# TECHNICAL BULLETIN

## CONVERSION FROM PRESSURE SWITCH ACTIVATED TO EPO ACTIVATED AUTO-REIGNITION SYSTEM

All 369I-I Series helicopters equipped with 250-C18 engine and 369H90118, 369H90118-501 or 369H90118-503 auto-reignition

This Service Information Notice lists a procedure to install the M50033 N/NR engine out warning kit and to convert the 369H90118, 369H90118-501 or 369H90118-503 pressure switch activated auto-reignition system to 369H90118-505 EPO activated auto-reignition system on helicopters equipped with 250-C18 engine. Conversion will result in faster reaction time.

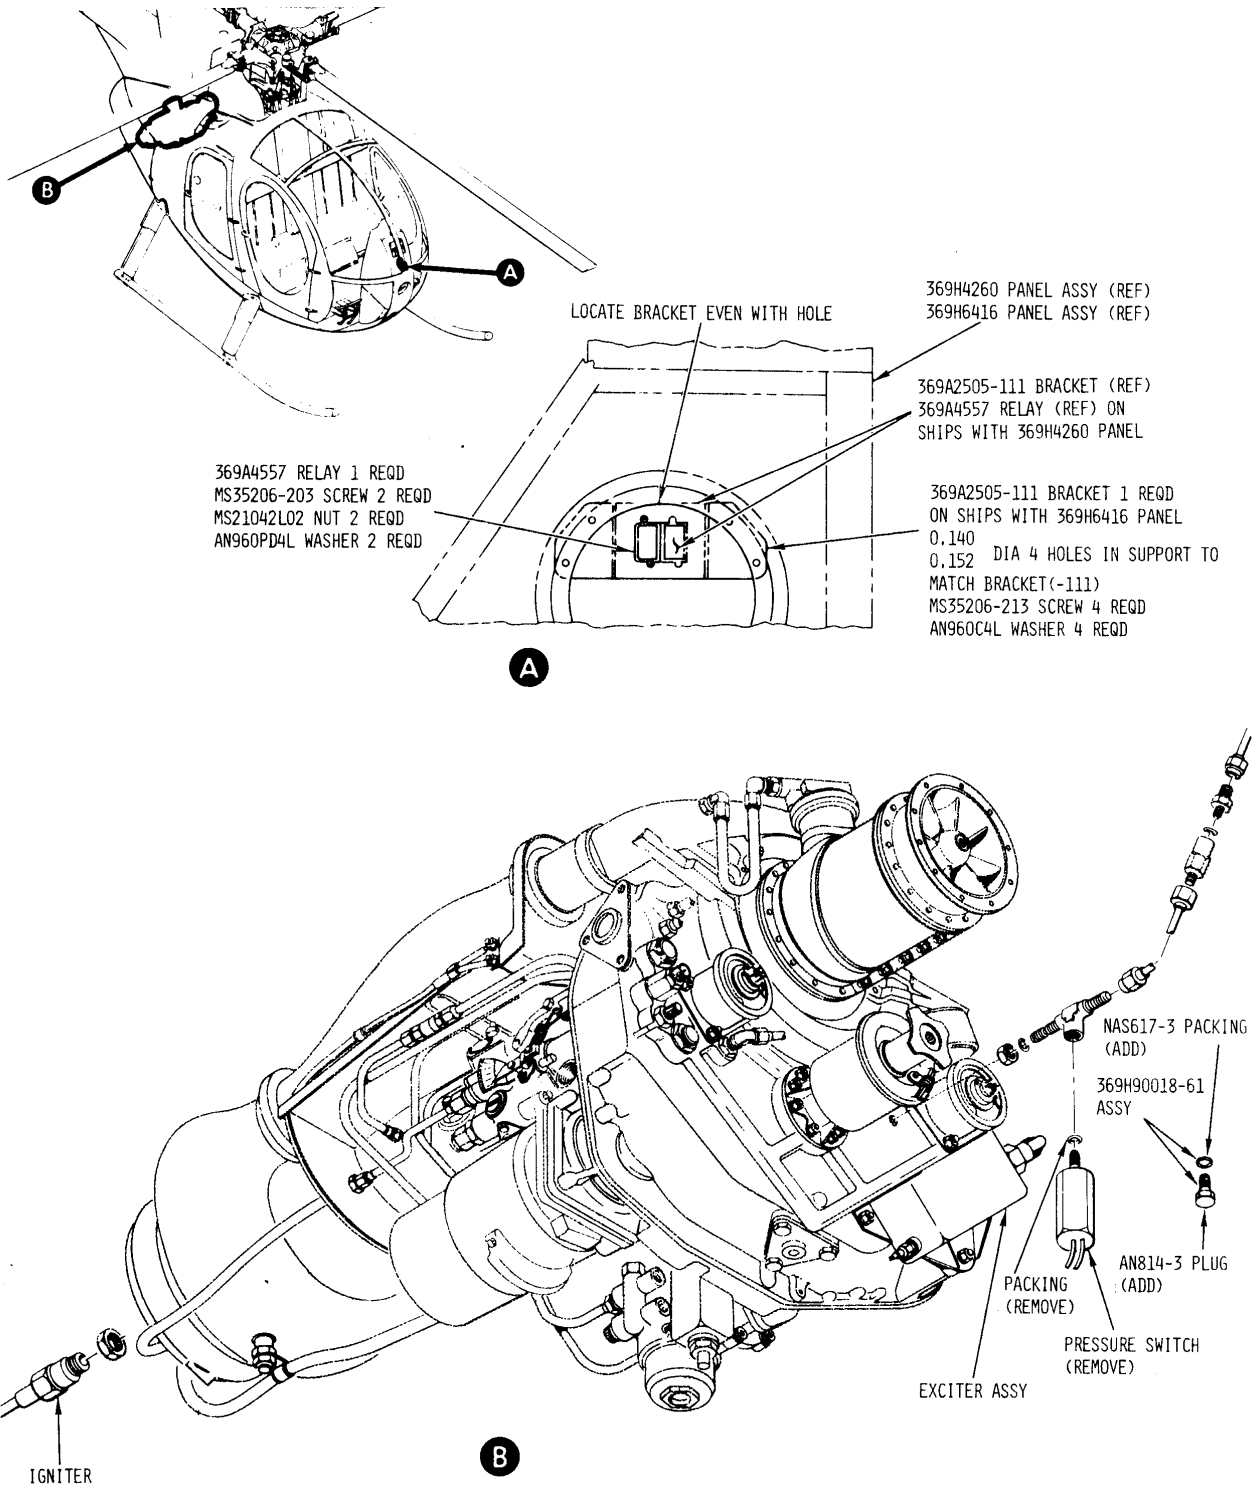
5. Remove MS25224-1 switch guard and MS24509-7 1/2 circuit breaker (CB124) located on auto-reignition switch panel.

6. Install MS35059-22 switch (S11) in hole where circuit breaker was.

**NOTE:** The following changes to auto-reignition wiring result in reidentification of 369H90118-11 diode isolator assembly and 369H90118-21 switch panel assembly to 369H90118-51 and 369H90118-81 respectively.

7. Install wiring as shown in wiring diagram (Figure 2) and wire table (Figure 3). Cover jumpers with insulation sleeving.

**Figure 1. Installation of 369H90118-61 and 369H90118-71 Assemblies**

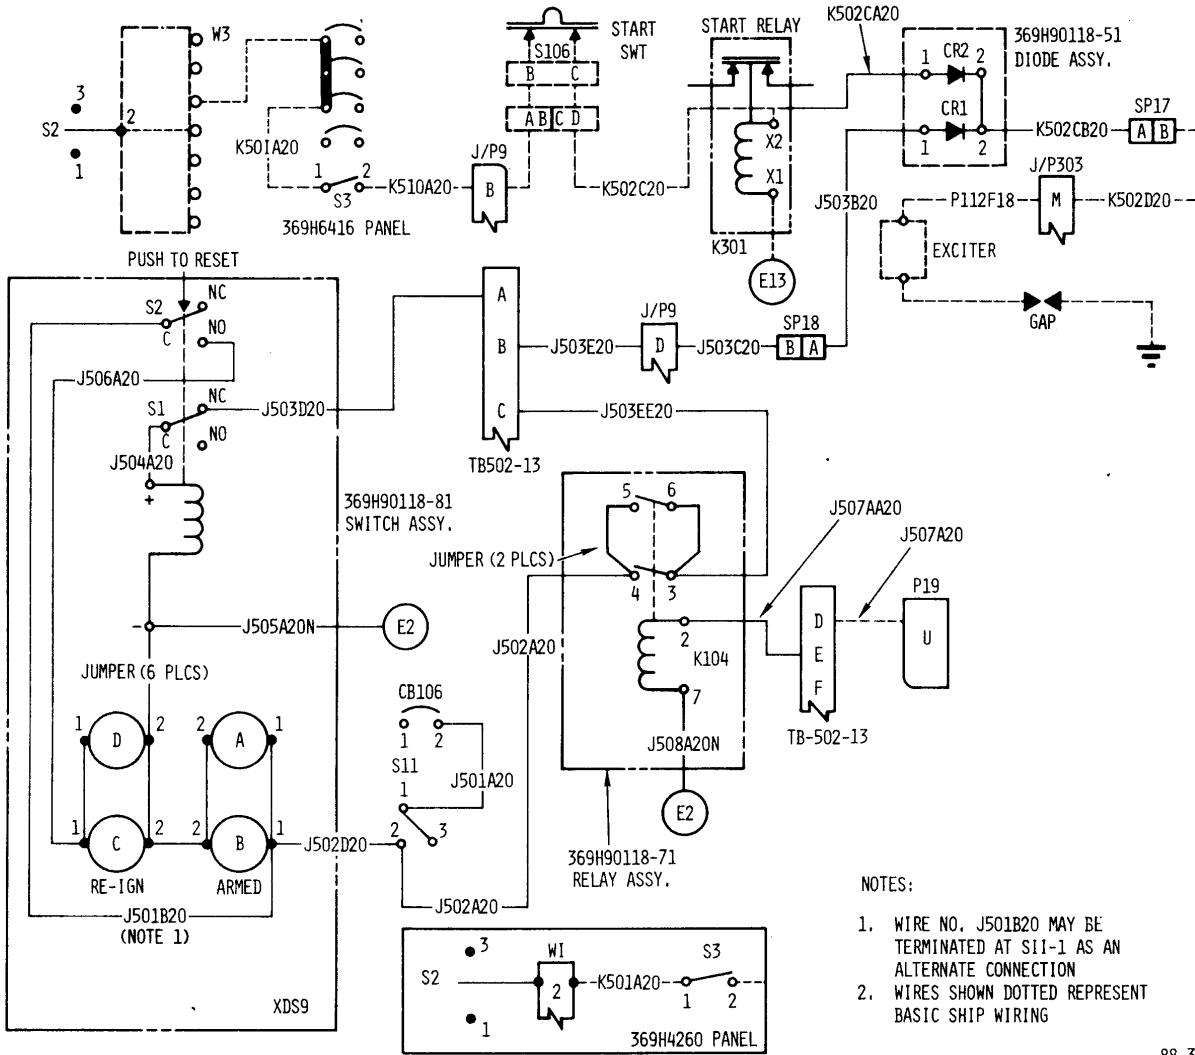
1. Remove 369H92025-3 or 369H92040 pressure switch from AN783C3 tee.
2. Plug tee with 369H90118-61 assembly. (See Figure 1).
3. Remove wire No. J503A20 and J502B20, 369H90118-31 angle and CA3100E10SL-35F80 connector (J302).

4. Install 369H90118-71 relay assembly as follows (See Figure 1):

(a). Remove fairing from left side of instrument panel. (Refer to Section 2 of Basic HMI) As required, drill four 0.140 to 0.152 inch diameter holes. Use No. 26 drill.

(b). Install 369H2505-111 bracket on left side of instrument panel as shown.

(c). Install 369A4557 relay (K104) on bracket as shown.
